September 21, 2023

MTE File No.: 42446-200

**RE: Letter Environmental Impact Study (EIS) – Addendum to Original Letter EIS  
Addressing Terms of Reference – 1494 Commissioners Road**

Figure 3: Development Proposal Overlay

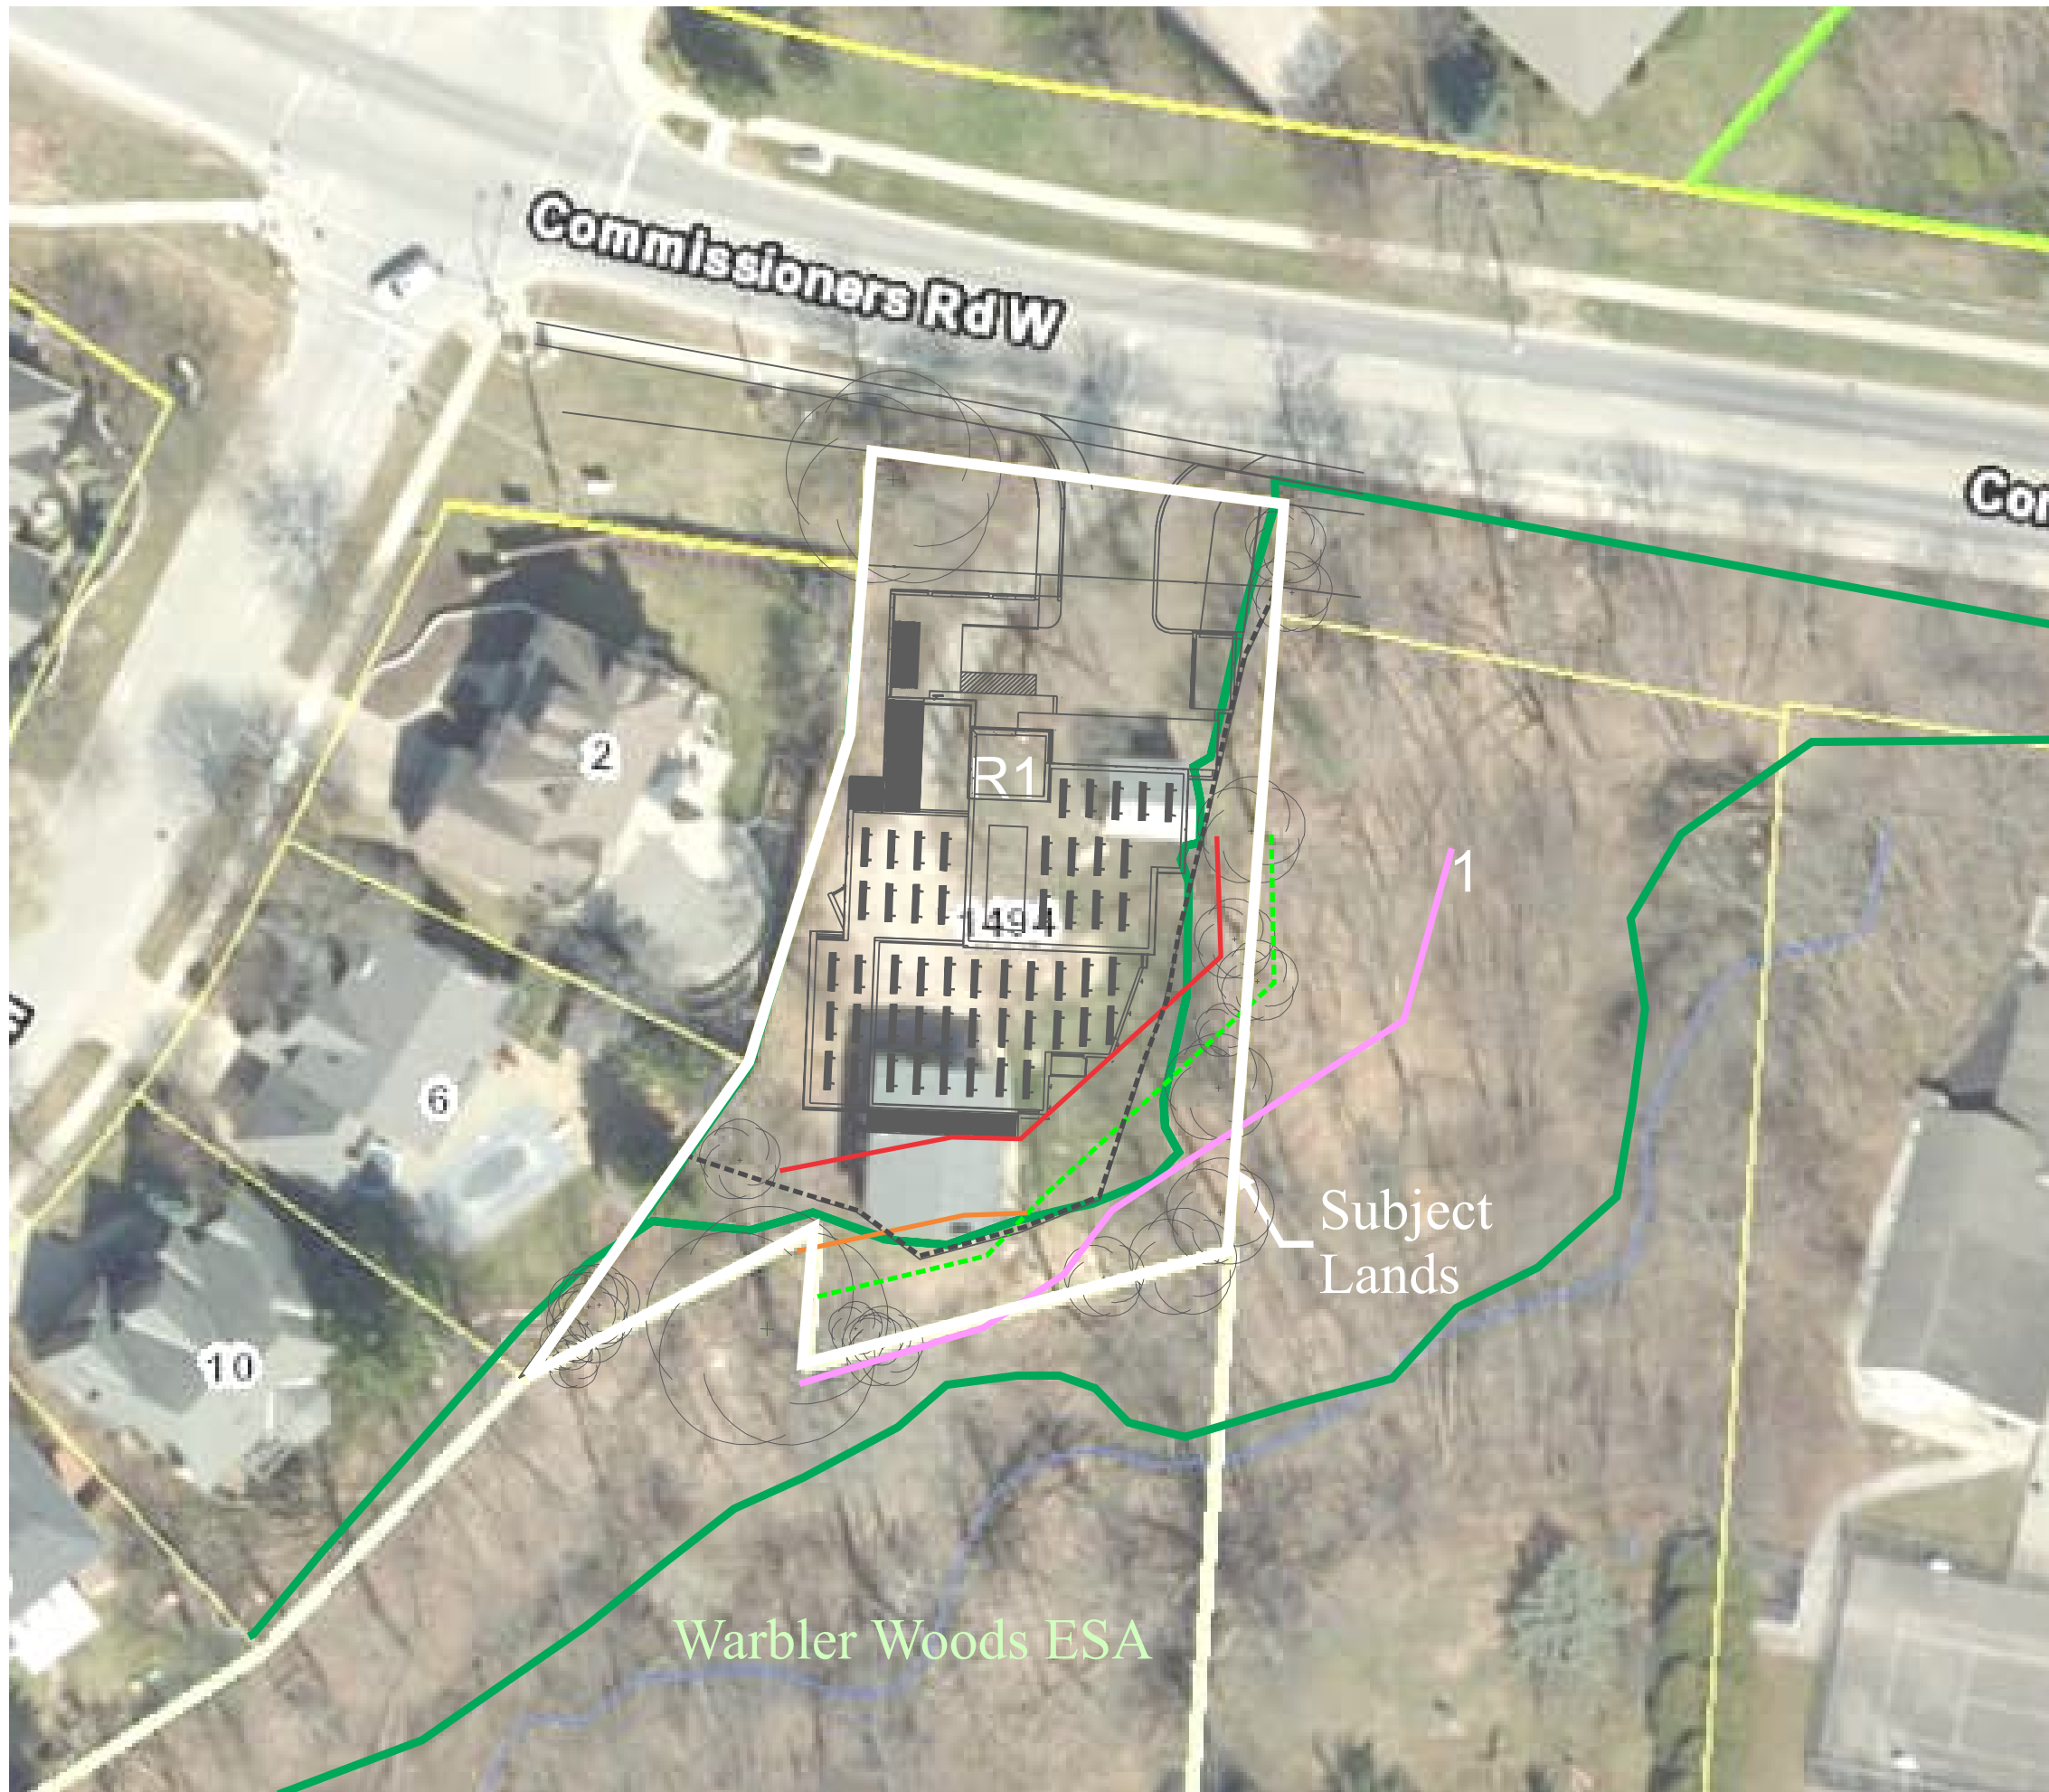
Additional 2022 City Pre-consultation comments: As a result of updated geotechnical review [Figure 3], the building has been shifted to the north. An area at the back, currently the location of the existing building, will be restored to a naturalized landscaped area after the existing building is removed. While the City pre-consultation discussion suggested this rear yard area be called a buffer, we disagree given the current area is a structure and the shift in the new building location is strictly hazard related. The rear yard to be naturalized would more appropriately be named a hazard setback. This area should be rezoned appropriately to recognize the development does not require additional setbacks once an OS zone is applied.

The snow storage on the zoning concept plan [Figure 3] is now shown along the west side of the entrance, away from the natural area to be protected.

This report has been completed as part of the zoning application. The development limit incorporates the recommendations in this report (exp, October 2022). The updated Erosion Hazard limit is shown on Figure 3.

Figure 4: Landscape Plan

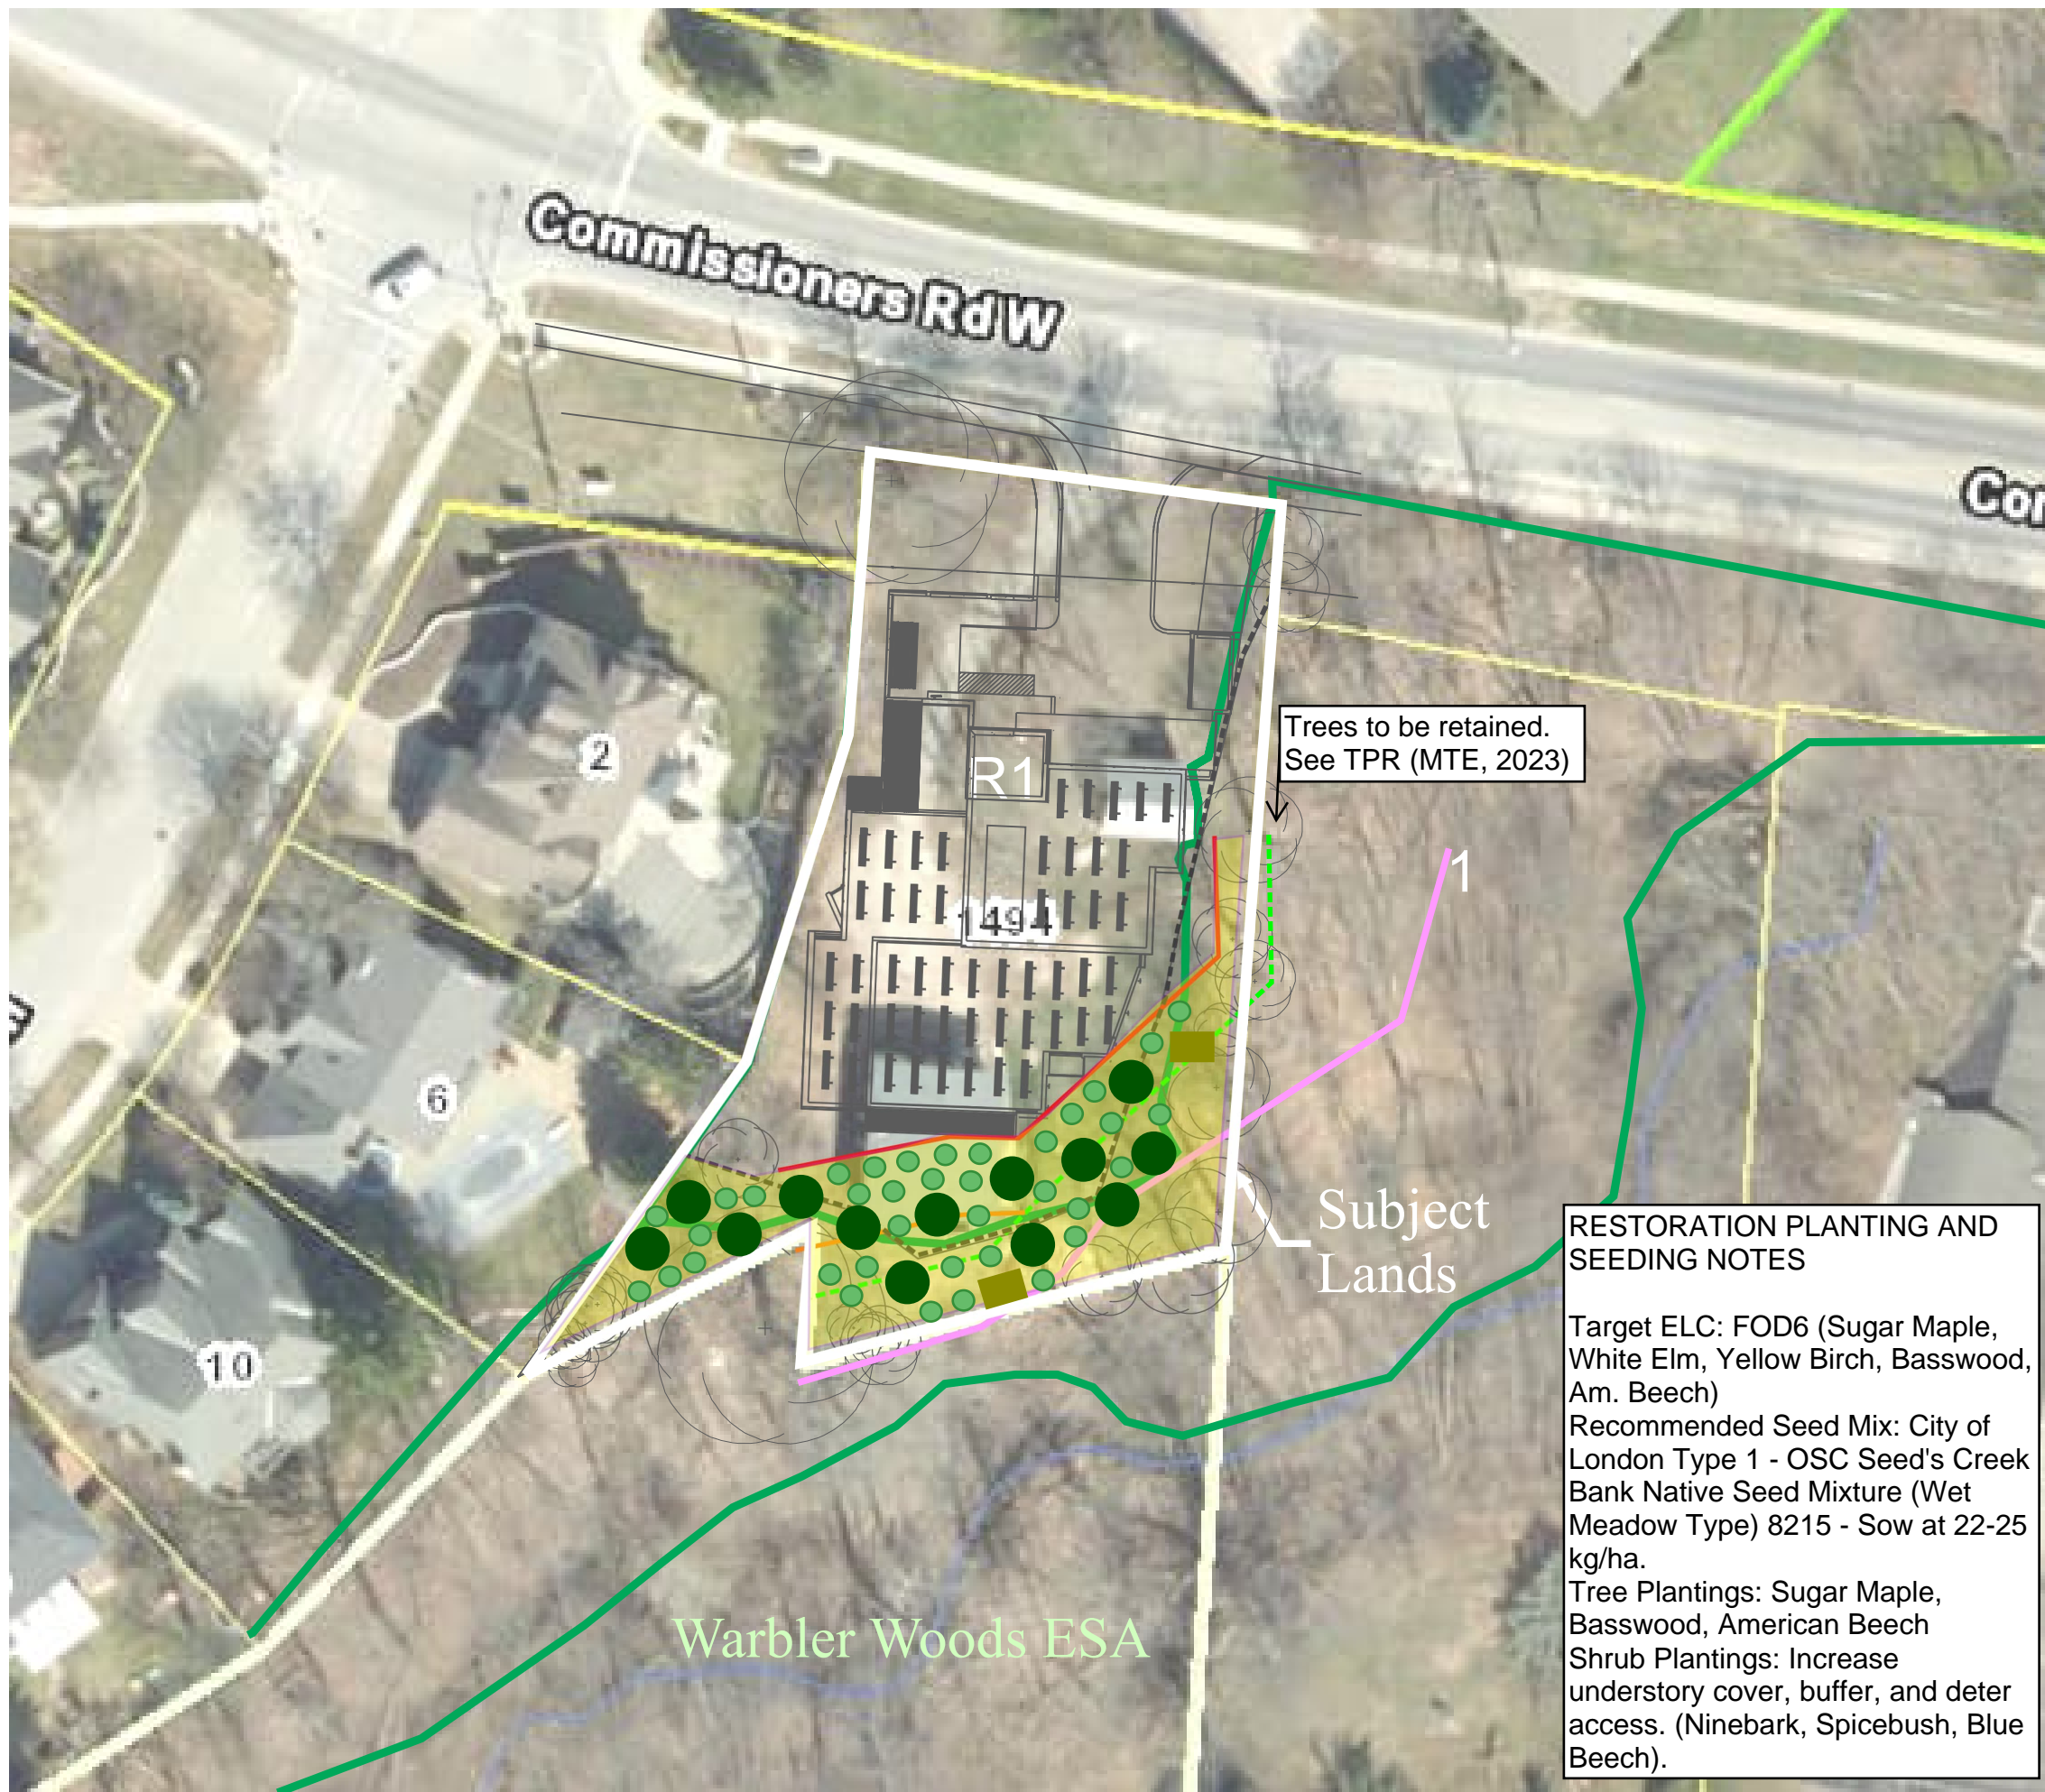
**A landscape plan demonstrating the naturalization of the mowed area under the dripline will accompany the application.**

Additional 2022 City Pre-consultation comments: See above and Figure 4 for added landscape concept at the rear of the property.

A landscape plan demonstrating the naturalization of the mowed area under the dripline has been completed [Figure 4]. Some additional shrub and tree planting is also proposed in areas where the erosion hazard limits (discussed later in this letter) extend beyond the original development limit line. The area between the building and naturalization landscape area will remain as maintained lawn or gardens.
